STAFF REPORT

APPLICATIONS RZ/FDP 2010-LE-009

APPLICANT: MR Lewin Park Capital, LLC

PROPOSAL: To rezone 13.45 acres from the R-1 District to the PDC District for the construction of five office buildings and associated parking structures or optional four office buildings, one hotel and associated parking structures.

DATE: MAY 01, 2020
 DEB ENG DWL CADD
 SCALE: AS NOTED
 PROJECT/FIELD NO. V5284
 SHEET NO. 2

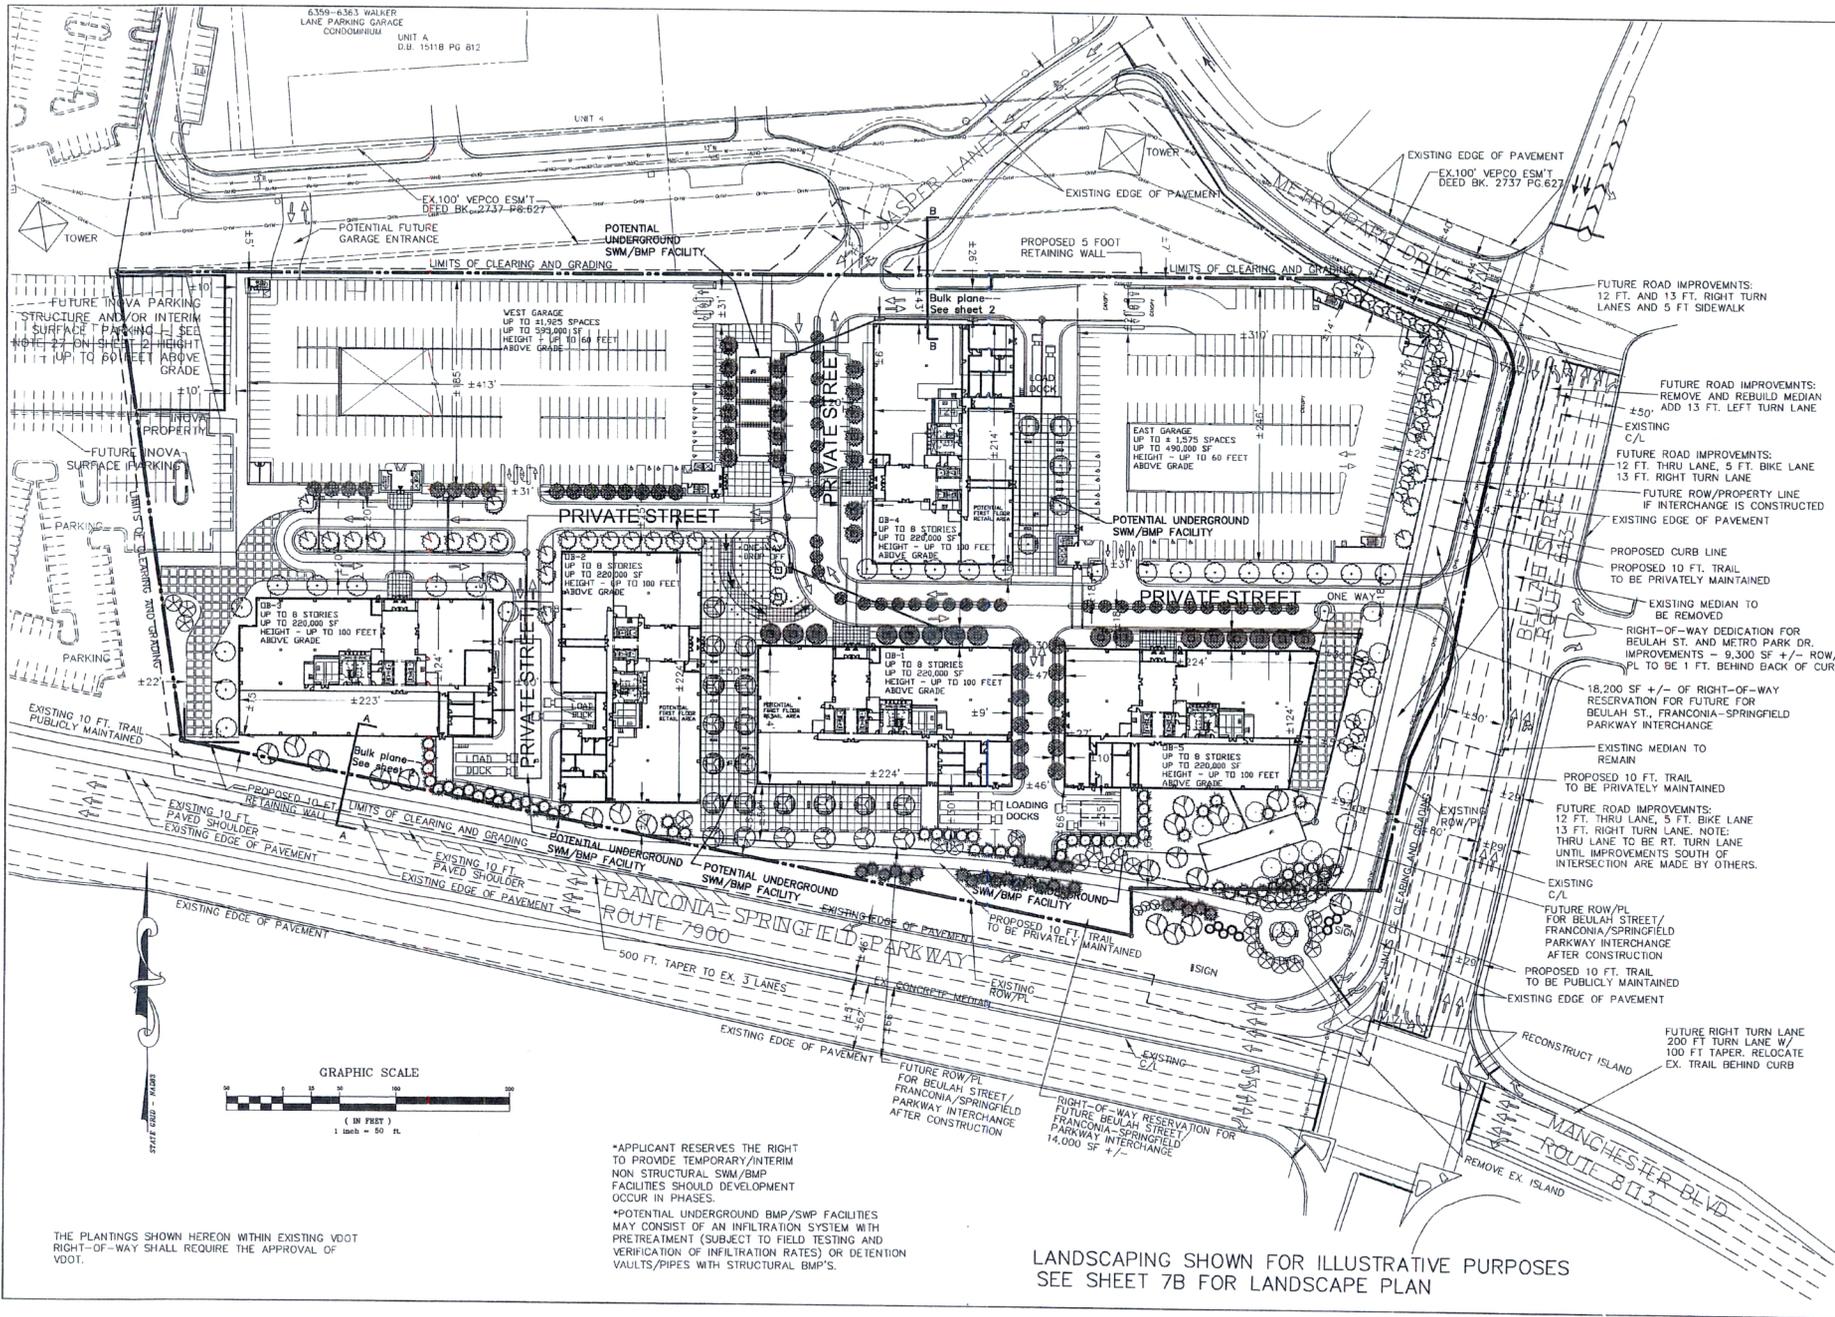
3. **Comment:** : It appears the Applicant is requesting a modification to the transitional screening and barrier requirements for the portions of the site adjacent to the single family attached dwellings, as stated in the justification on sheet 7C. However, the modification request with a justification sites prior Zoning Ordinance requirements and does not appear to be in conformance with ZO 13-305. In addition, transitional screening calculations have not been provided and it is unclear if the proposed landscaping along the southern portion of the site meets the intent of the transitional screening yard and barrier requirements.

4. **Comment:** : It appears the Applicant is requesting a waiver of the peripheral parking lot landscaping requirements for the site as stated in the various notes on sheet 2, however, a justification for this waiver has not been provided and it is unclear why the waiver is being requested. In addition, peripheral parking lot landscaping calculations have not been provided and it is unclear if the proposed landscaping meets the intent of the peripheral parking lot landscaping requirements.

STORMWATER COMPS &
ADEQUATE OUTFALL

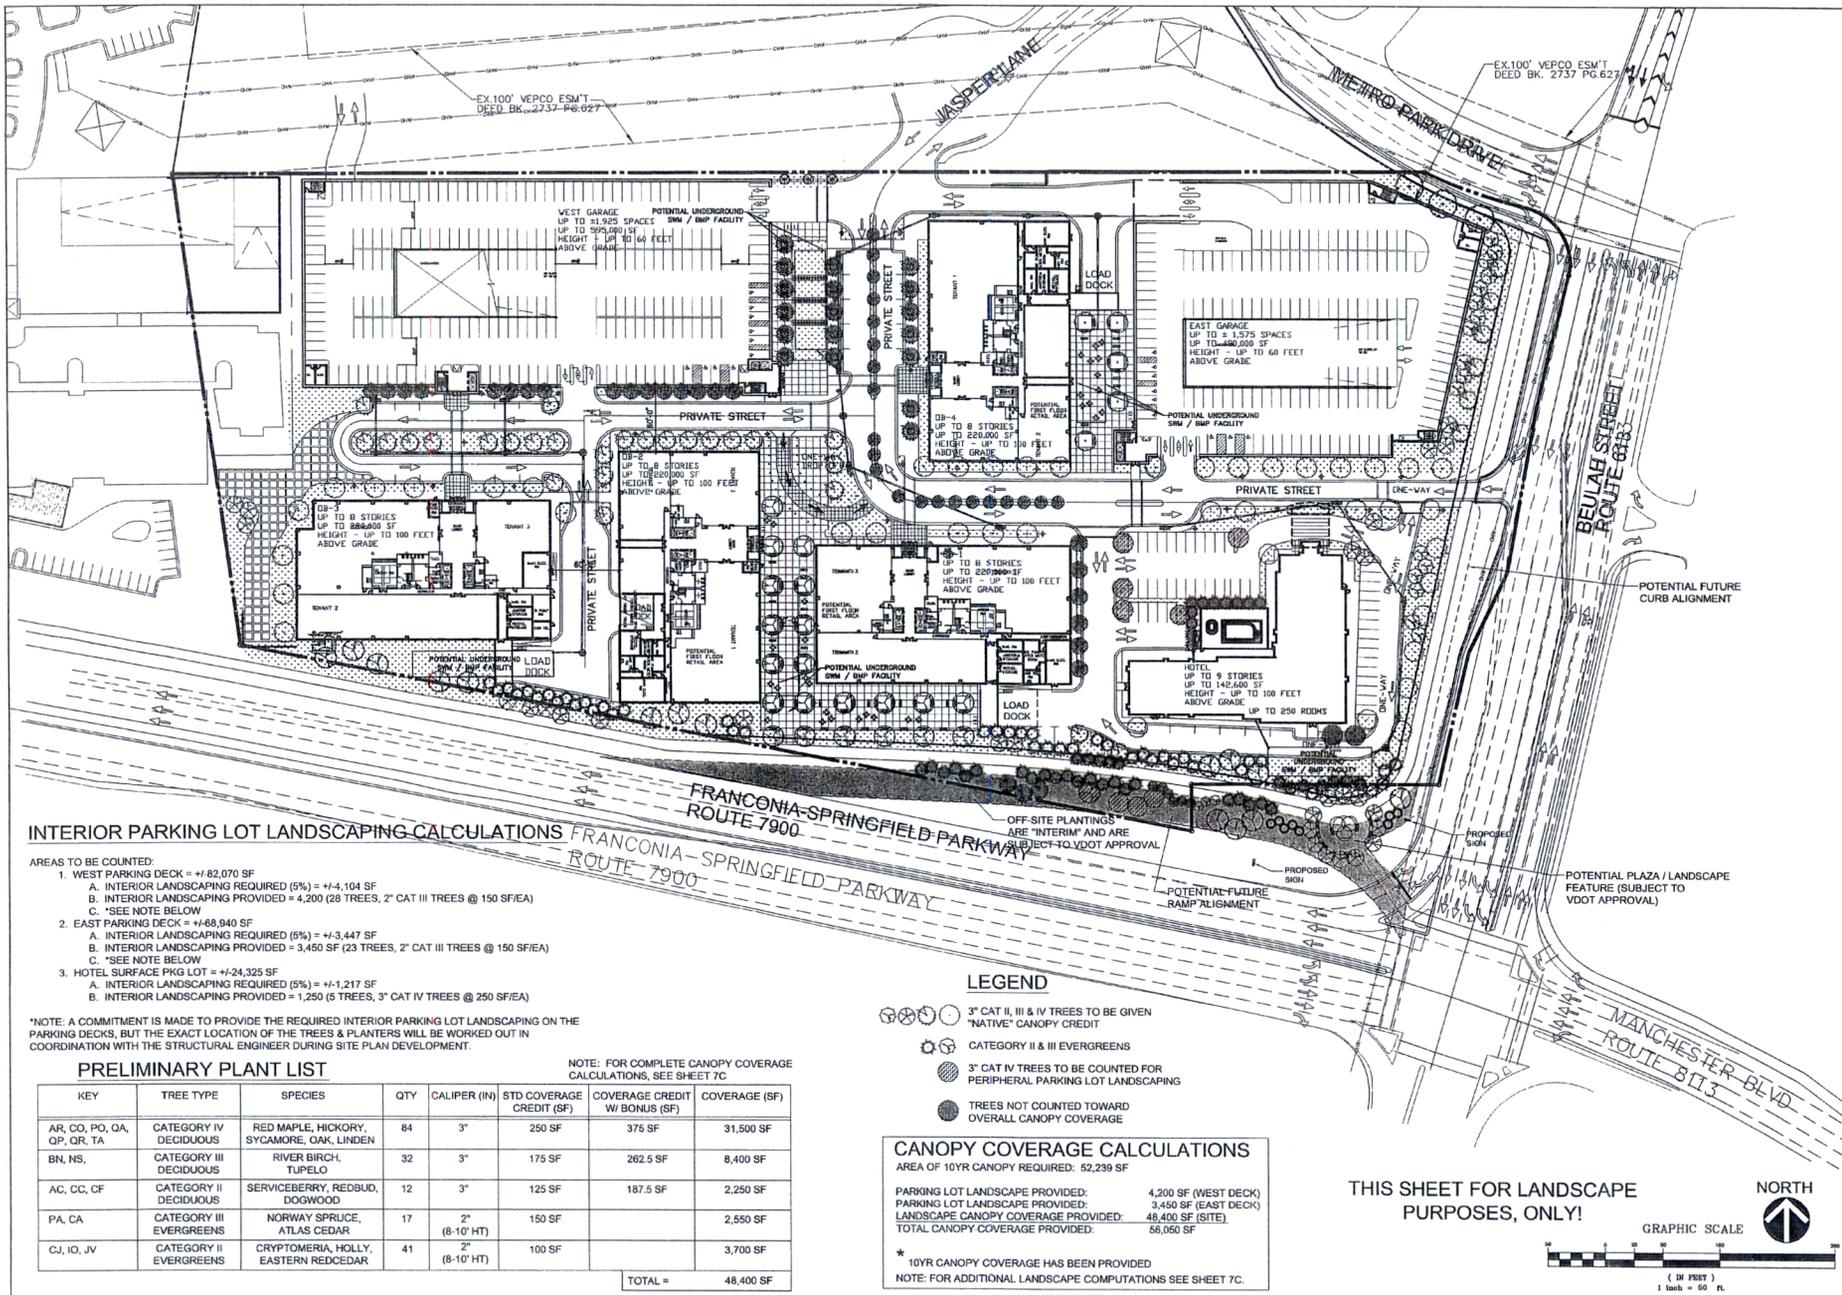
The applicant proposes to provide multiple underground stormwater management/best management practices facilities to meet the stormwater management requirements for the site. Department of Public Works and Environmental Services (DPWES) staff reviewed the application and noted that the following items from the submission requirements had not been provided:
